SUBJECT: NuScale Power, LLC Supplemental Response to NRC Request for Additional Information No. 132 (eRAI No. 8971) on the NuScale Design Certification Application

Response to Request for Additional Information Docket No. 52-048

eRAI No.: 8971

NRC Question No.: 03.08.04-13

Operating Temperature Convection Profiles for RXB

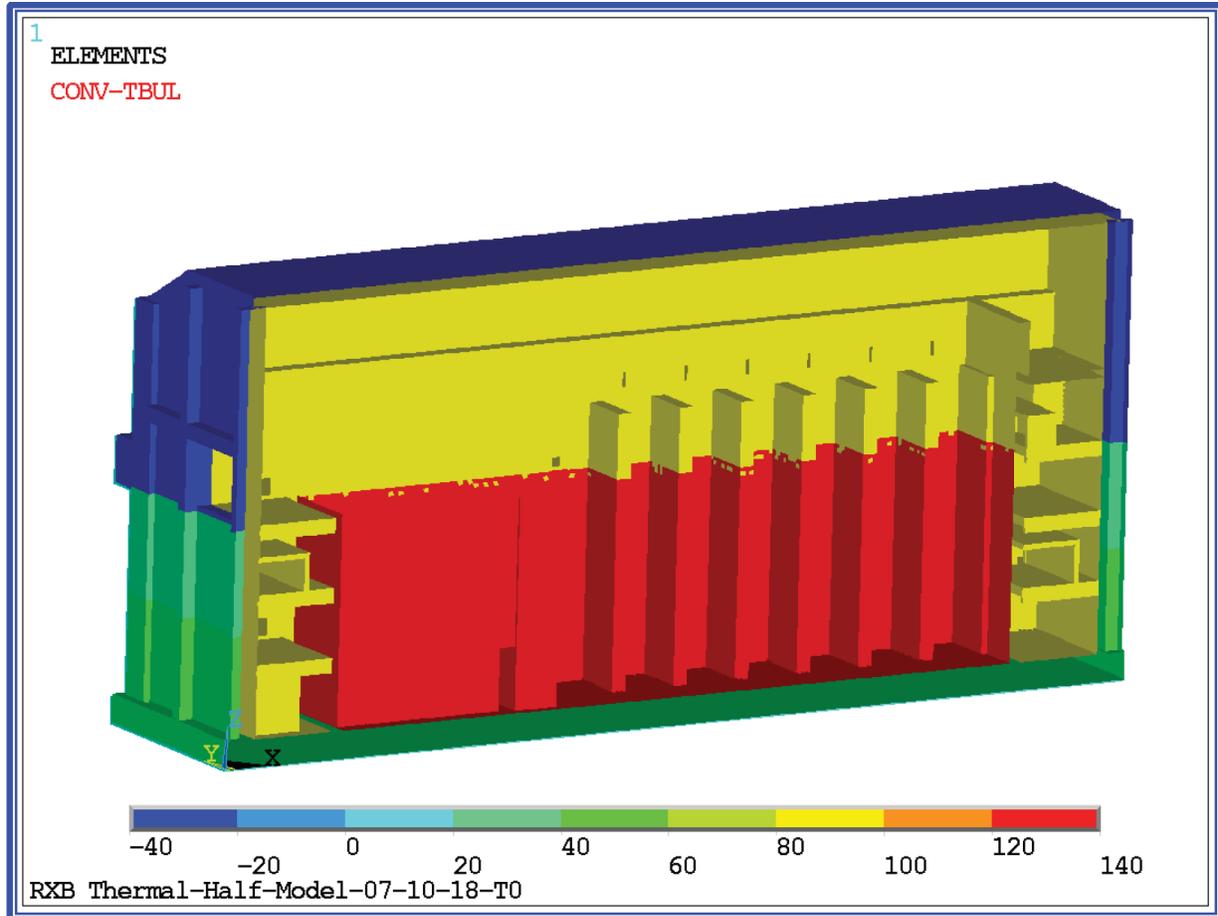
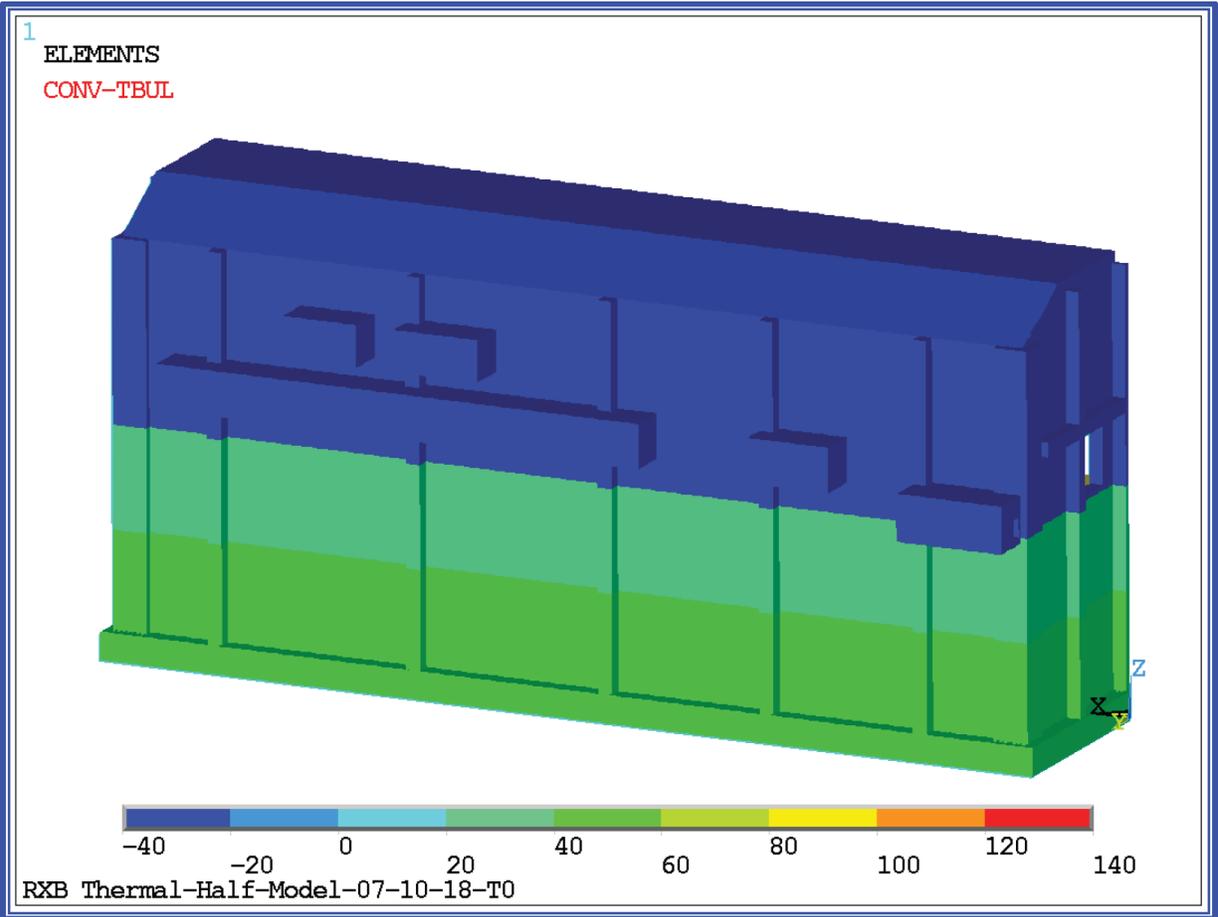
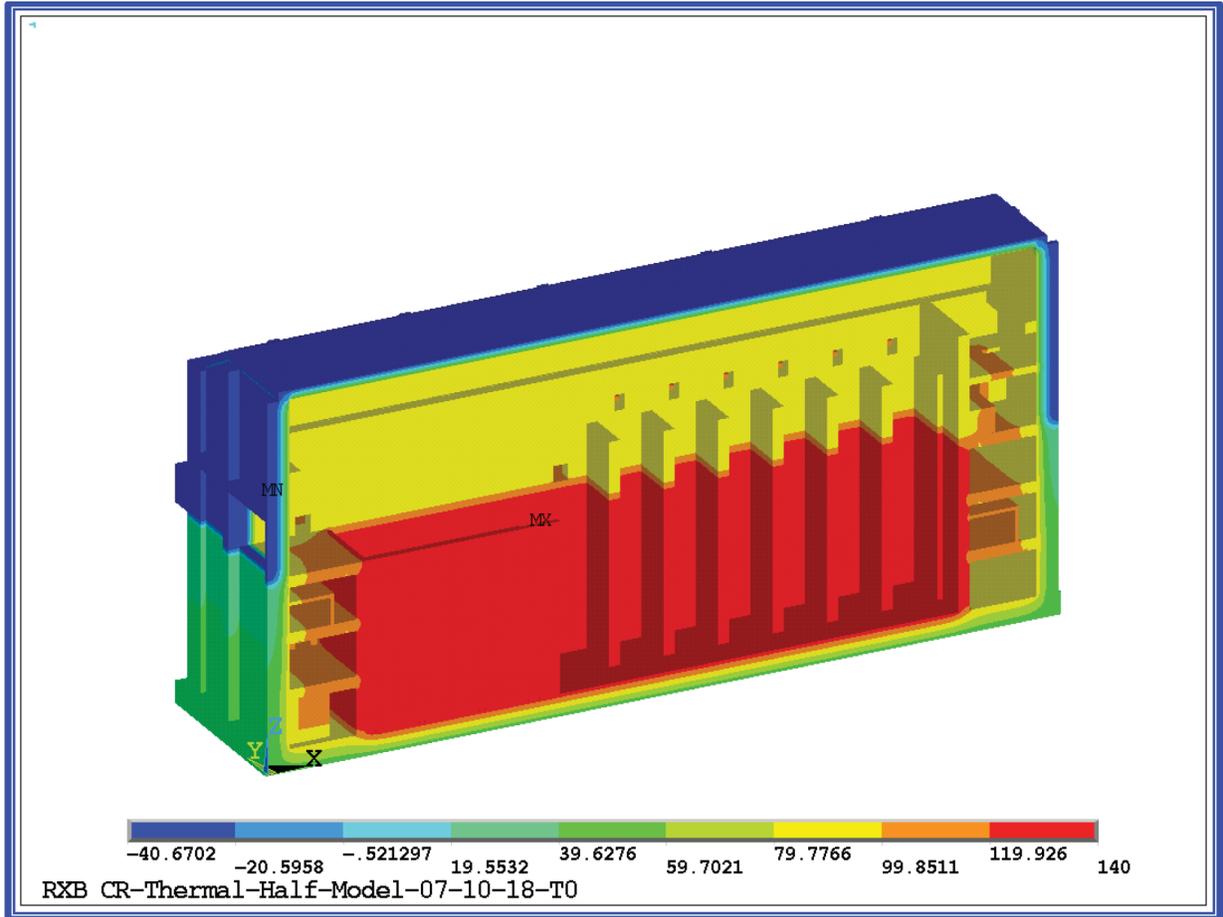
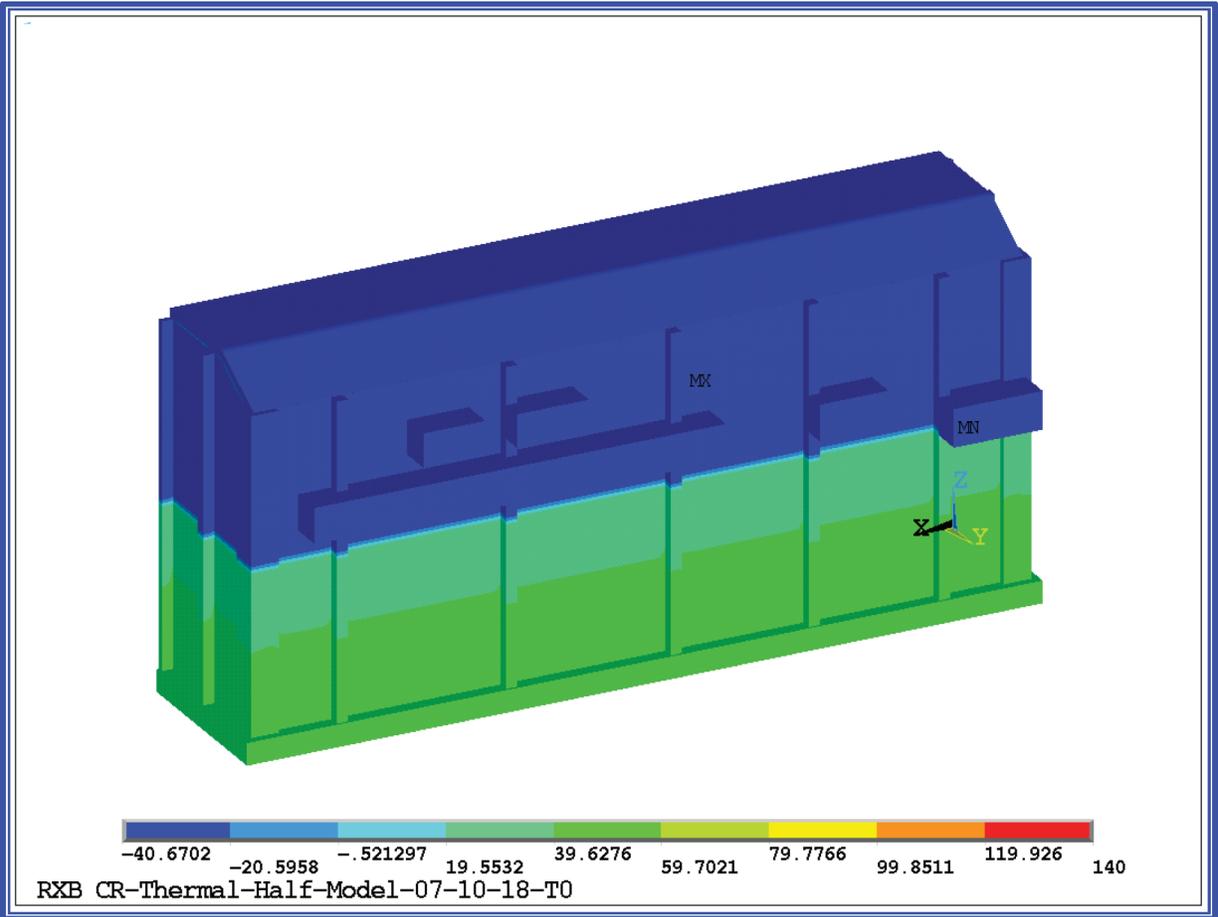
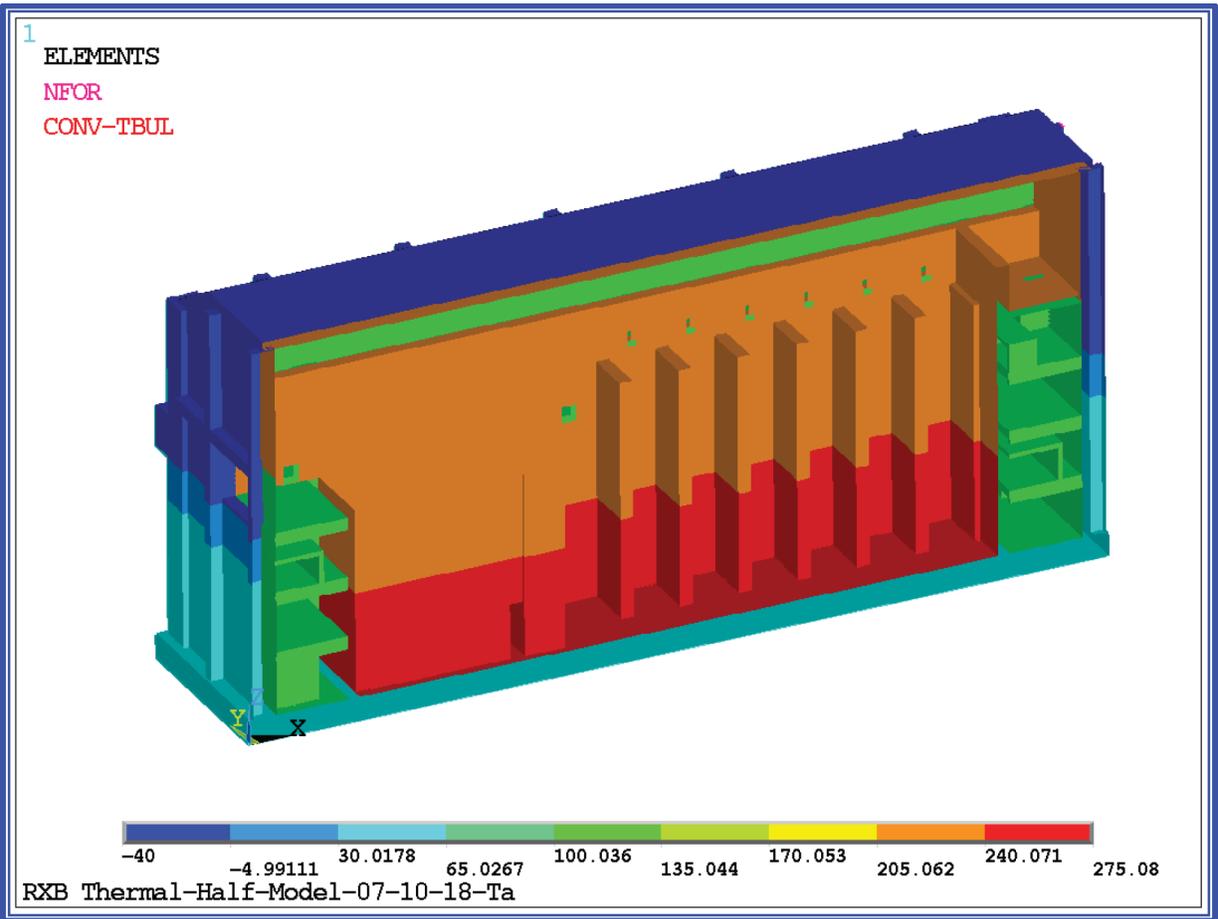
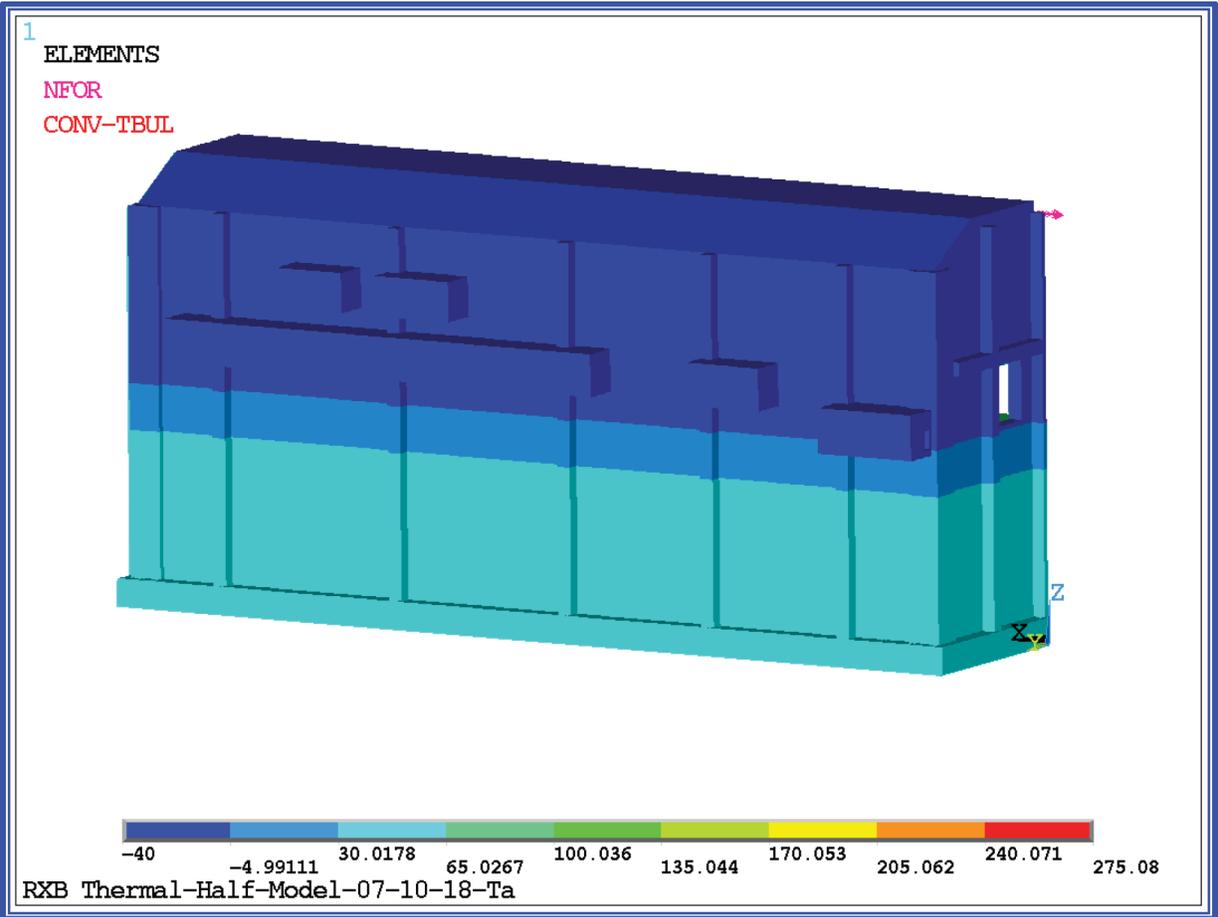
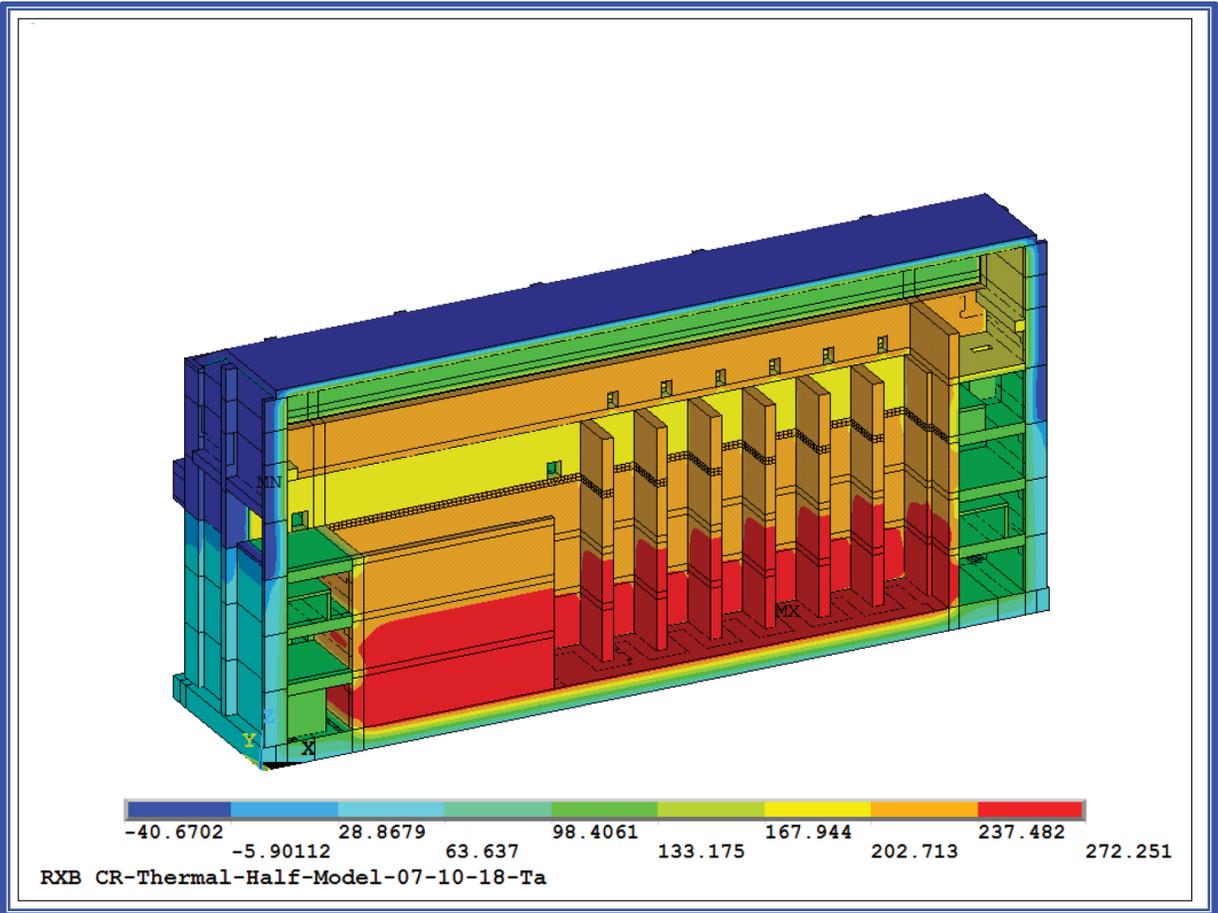
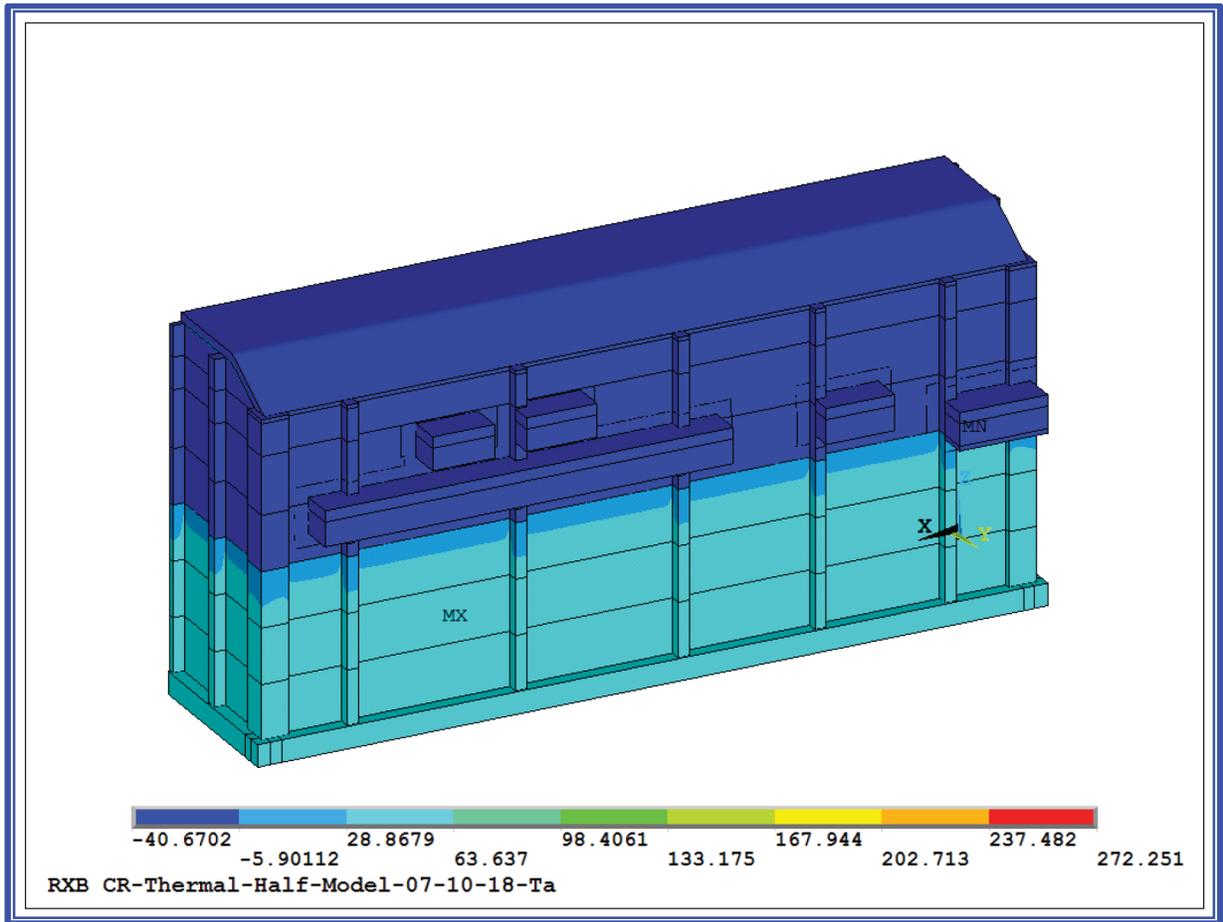
2. Staff Feedback - Section 2.3 RXB discusses external and internal temperature ranges applicable to the NuScale Design. From this information is not clear to the staff the thermal load case(s) used in the analysis. Please provide a full profile of the temperatures for the thermal load cases T_0 and T_a for all interior and exterior areas/regions. If different than the full set of temperature ranges identified in the response, provide the basis for the selected sets of temperatures.

Response - The following figures provide a graphical representation of the applied thermal loadings for both the T_0 and T_a conditions, as described in Section 2.3.

Figure 9 - Single Elements from Pool Wall - Middle (Grid Line C) with Insufficient Thermal Ta+Pa Strain Capacity for Load Combination 9-9 in X Direction

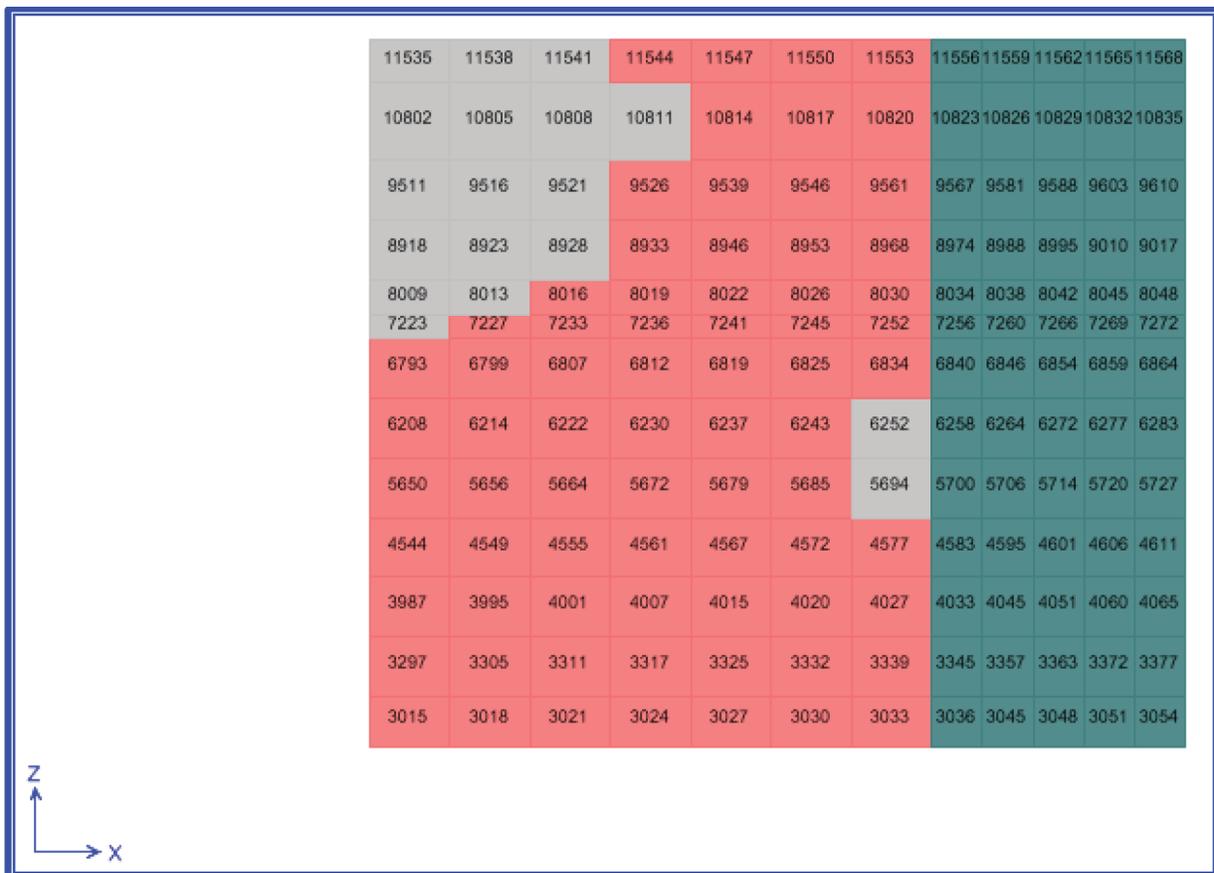
4. Staff Feedback - Section 3.1, Step 2, states: “For computation of average strain, an effective length of approximately 4 times the thickness of the structural component (such as wall or slab) is considered. However, for the walls with liner plates such as pool walls, elements that correspond to larger lengths of the walls (up to the extent of the entire wall length) can be used for average strain determination...” It is not clear to the staff whether the entire wall length for average strain determination was actually used for the results presented in the RAI response. If so please clarify the specific walls in the RAI response for which it was used and provide justification that demonstrates that the liner plates permit the extending the length for the purpose of averaging the strain. If the entire length was not used for the purpose of averaging the strain, please remove the criteria from the response and respective DCA Part 2 Tier 2 markups.

Response - The specific locations where strain averaging were employed are indicated in FSAR Tables 3B-59, 3B-60 and 3B-61 for SDH, SDH+To and SDH+Ta+Pa load combinations respectively. Accordingly, Strain averaging for thermal and pressure loads was used on the following locations in the RXB:

The maximum number of elements used in an averaging group was 10 and occurred at the Pool Wall - Middle (Grid Line C) and consisted of the following elements: 11535, 10802, 9511, 8918, 8009, 7223, 6793, 6208, 5650, and 4544.

Even with this higher number of averaging, it did not extend for the full length of the wall as shown below in Figure 9. The statements of full wall averaging are modified in the Section 3.1 of the response and respective FSAR Tier 2, Section 3B.1.3 markups.

It is rationalized that the liner plates along with its anchors to concrete walls provide confinement and prevent water leakage. A304L material is highly ductile and can have much higher stain acceptance ~ 0.004 This is the rationale for considering larger lengths for determining average strain rather than a few elements to comprise a length of 4 times the thickness.
